**Casey Planning Scheme Amendment C286case
Collison Estate Development Contributions Plan**

Panel Report

1 July 2024

Panel Report pursuant to section 25 of the PE Act

Figure 5 Amended interim concept layout for IN04

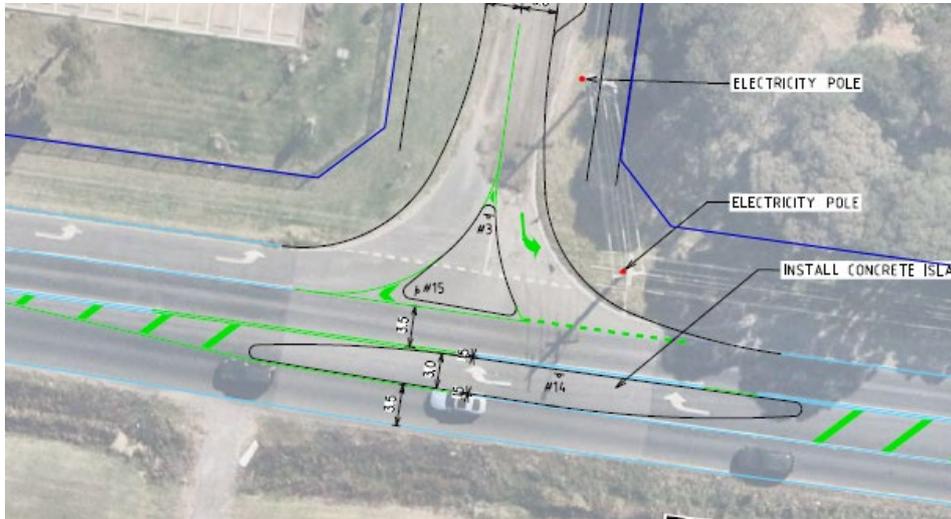
Document	Change	Basis
DCP only	Amend IN04 concept plan to: <ul style="list-style-type: none"> - redesign an existing traffic island resulting in an increased width from 2.7 to 3.0 metres - inclusion of note 'subject to approval of the Head, Transport for Victoria' - inclusion of the ultimate Berwick-Cranbourne Road profile 	To respond to DTP submission and to clarify that Casey Fields Boulevard and Linsell Boulevards are Council roads and not State arterial routes. Changes have no cost implication
	Designate Linsell Boulevard and Casey Fields Boulevard in the maps as a 'Council Arterial'	To respond to DTP submission and clarify that Casey Fields Boulevard and Linsell Boulevards are Council roads and not State arterial routes
	Development Plan costing detail (KLM Spatial) as additional Appendix B document (extra drainage plan)	Identified in Ainsaar evidence
DCP and DCPO22	Correct levy rate from \$847,411 to \$859,412 per hectare NDA	Council advised this was predominantly the result of an error relating to the land budget and valuation for 19 Collison Road and that a correction letter was sent to all owners and occupiers in the precinct and other key stakeholders to explain the discrepancy early in the exhibition period. Approximately \$2,000 of levy increase related to additional intersection splays.

Mr Chisholm's evidence was that IN04 including Council's changes were appropriate. His evidence included an amended concept layout plan for IN04 which showed a widened traffic island (Figure

- replace the Concept Layout for IN04 with the amended plan: ‘Concept Interim Layout – Collison Road & Berwick-Cranbourne Road (IN04)’, Traffix Group, 2 May 2024 included in Appendix B of Mr Chisholm’s evidence

Figure 6 Proposed ultimate concept layout for IN04

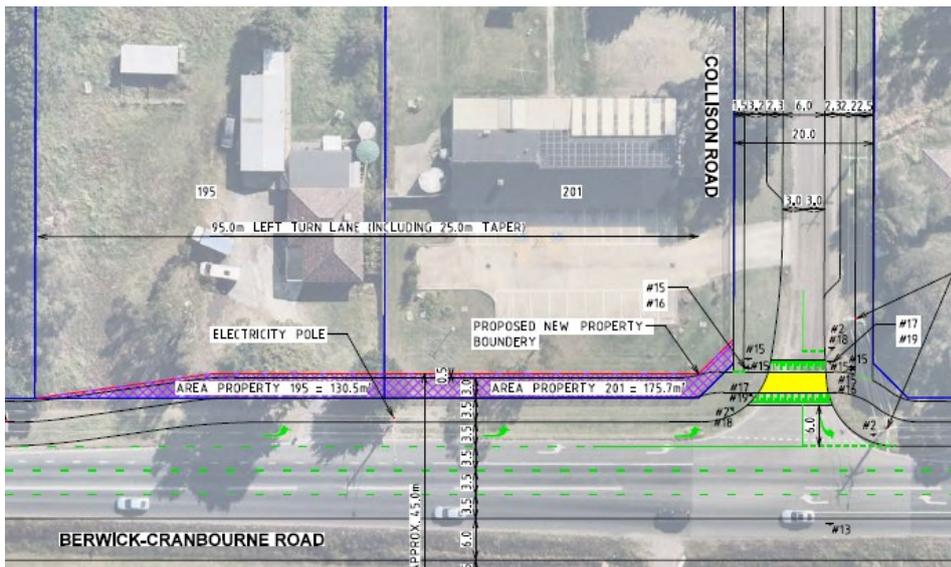
Document	Change	Basis
	Adding a land project component to IN04 of approximately 306 square metres for turn lanes in the ultimate intersection layout	To respond to DTP submission. Changes valued at approximately \$143,000, resulting in DCP levy increase
	Move the intersection land costs 'splays' for ultimate layout of IN02 and IN03 from the adjoining road projects (RD01 and RD04) and include as a land component of IN02 and IN03. Update land budget, total costs, levy and include interim and ultimate layout plans in DCP in Appendix B	Change made for consistency with other intersection projects and DCP evidence
	Add intersection splay land (north and south) to the land component of the Heather Grove Main Street project (RD03). Make changes to reflect updated land budget, total costs, and levy. Amend RD03 Main Street Layout Plan in Appendix B to show ultimate roundabout intersection (Casey Fields Boulevard/Heather Grove) splay land	Ensures ultimate land take for Casey Fields Boulevard/Heather Grove intersection is included in the DCP

5) and an additional plan (Figure 6) showing the ultimate concept including the additional land component required for the ultimate turning lanes project of approximately 306 square metres.

Figure 8 Amended concept layout for RD03

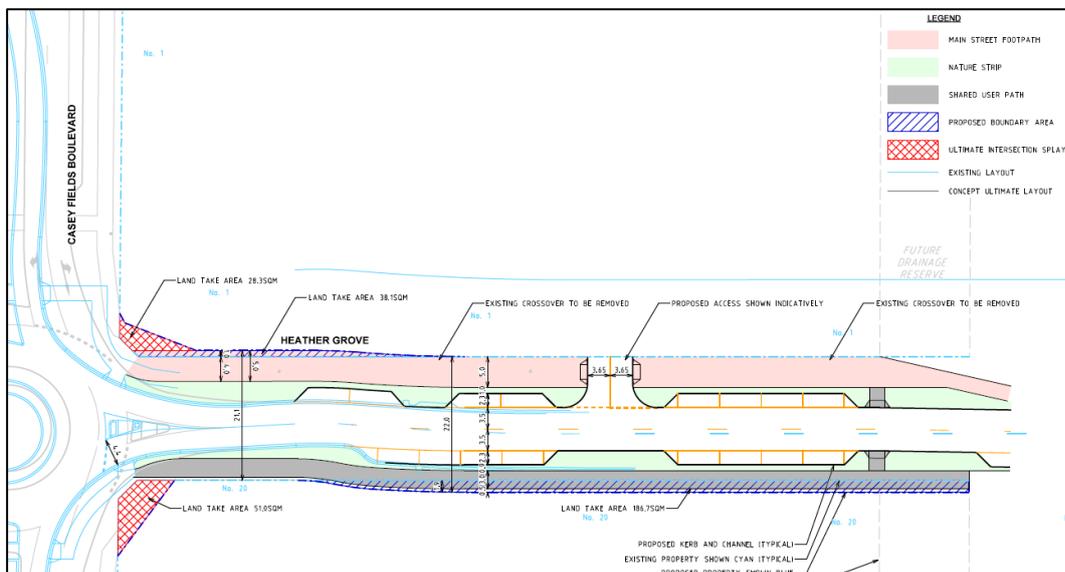
In relation to RD03, Mr Chisholm's evidence was the DCP included a concept plan for the Heather Grove 'main street' cross-section. This plan was designed to reflect the connection into the existing Casey Fields Boulevard/Heather Grove roundabout (interim treatment). Under ultimate conditions when Casey Fields Boulevard is duplicated, the intersection will be upgraded to a larger roundabout with two lanes in each of the northbound and southbound directions. The concept plan included in the DCP did not show the flaring required for the ultimate roundabout arrangement. His evidence included an amended version showing the land take for the ultimate intersection design (Figure 8).

- replace the Concept Layout for RD03 with the ‘Heather Grove, Cranbourne East Concept Layout Plan’, Traffix Group, 14 May 2024 included in Appendix C of Mr Chisholm’s evidence

Figure 11 Amended Interim Concept Plan for IN02

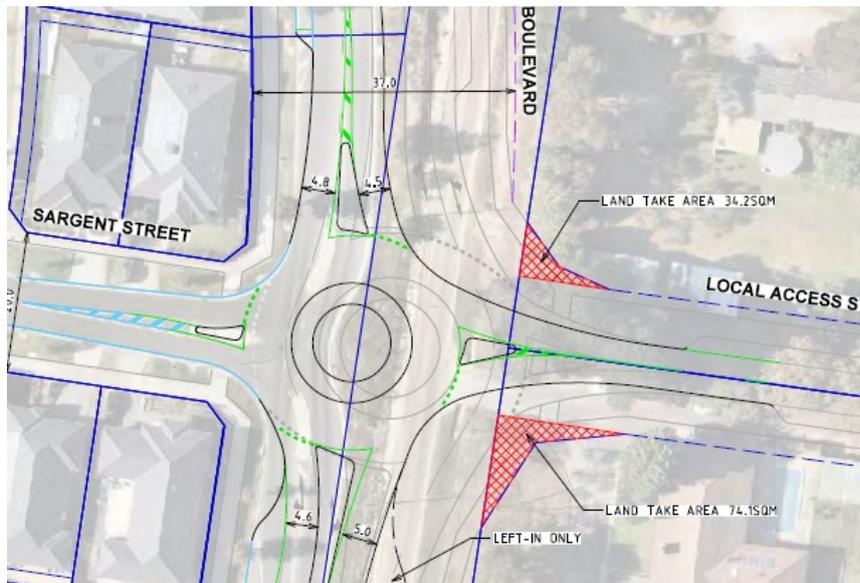
- the DCP includes intersection projects for the interim Casey Fields Boulevard roundabout at Sargent Street (IN02) with the land component for the ultimate intersection splays included within the associated road project (RD01)
- the DCP concept plans for IN02 show the concept ultimate roundabouts instead of the interim roundabout layout.

He advised this was potentially misleading because the interim roundabout layouts are what will be delivered and funded under the DCP. The purpose of the ultimate plans was to inform the land take component only. He provided an updated plan for IN02 in his evidence (refer Figure 11).

- replace the Concept Layout for IN02 in Appendix B with the ‘Casey Fields Boulevard/Sargent/Local Access Street Concept Plan – Interim Layout’, Traffix Group, 14 May 2024 included in Appendix D of Mr Chisholm’s evidence

Figure 12 Casey Fields Boulevard - Mayfield Road ultimate cross-section

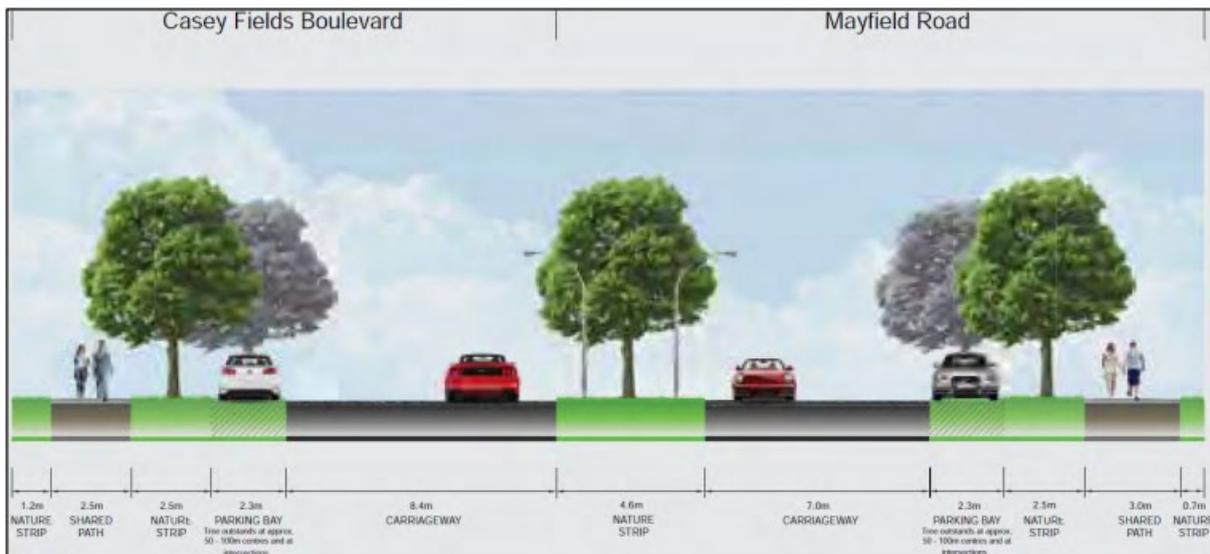
- the bi-directional nature (or "tunnelling effect") of the proposed atypical cross-section provided the potential for a driver to be heading towards two oncoming vehicles on opposite sides which would be exacerbated at night by vehicle headlights (refer Figure 13)
